Our reference: P-1080772-X4R1
Contact: Robert Walker
Telephone: (02) 4732 7409

**Council Response to Request for Advice on Environmental Impact Statement
- SSD-77336995 – ‘Subdivision of 121 Willmington Road Luddenham’ at 2903-
3017 Park Road, Luddenham**

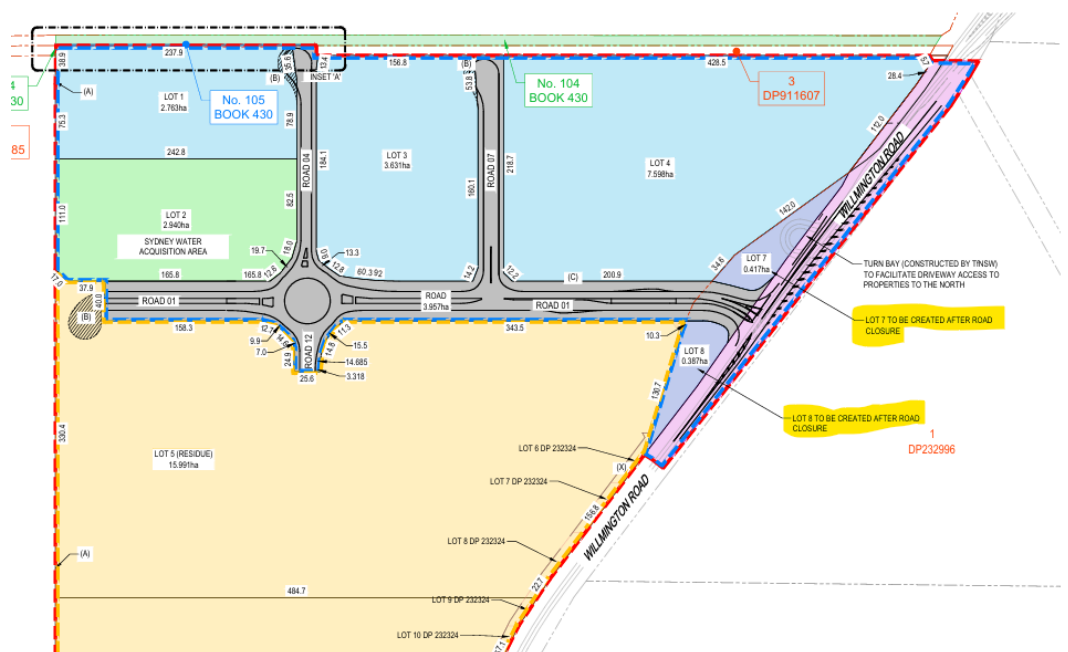
- a) The applicant will need to progress the road closure subdivision and purchase from Council prior to any construction or works commencing. These parcels are identified as Lots 7 and 8 on the below plan.

- b) For additional background on the road closure process, the subdivision of the road will need to occur before Council can formally close the road via Government Gazette and road closure registration. On successful completion of the formal road closure process, two Torren title lots will be created (proposed Lots 7 and 8). The applicant can then liaise with Council regarding the two lots.
- c) Whilst the road closure process is a separate process undertaken under the Roads Act, by Council as the Roads Authority, Subdivision is required under the EP&A Act to facilitate the road closure process.
